Queenax MWB 45 usage change

Cracked column with a boxing shelf mounted on MWB 45's

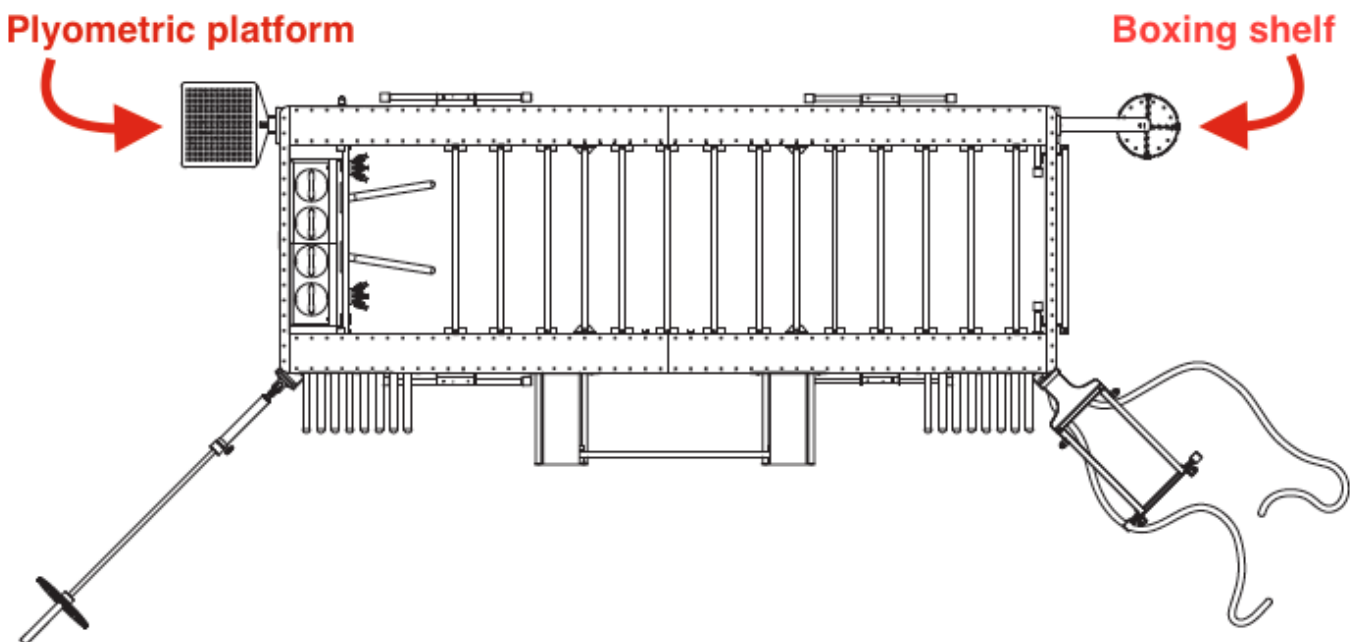
Using the Plyometric Platform or the Boxing Shelf on the corner mounted Mini Wall Bar 45's (MWB 45's) can cause the column to crack at the mounting point of the MWB.

On all units, the Plyometric Platform and Boxing Shelf shall only be mounted on MWB 25's or MWB 35's. All new shipments will have the proper parts for this change. Refer to the most current renderings for placement. **In no case should these optionals be mounted on MWB 45's.**
